Access Compliance Report

Public Rights-of-Way

| Intersection ID: 25988 | Main Street: BLUE_HERON_DR | Cross Street: NIGHTINGALE_LN | Location: SW |
| ADA ID: 11BFA24AA1BC | Ramp Type: Directional1 | Initial Pass/Fail: Fail | Overall Compliance: No |

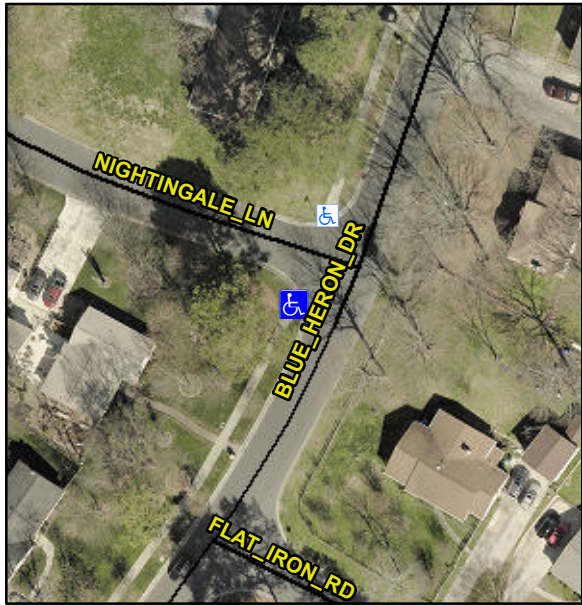
R304.5.3

| Compliance | Description | Data | Compliance | Description | Data |
|------------|-----------------------|-------|------------|-----------------------------|------|
| No | Ramp XSlope (%) | 3.7 | | | |

Remove & Replace Entire Ramp.
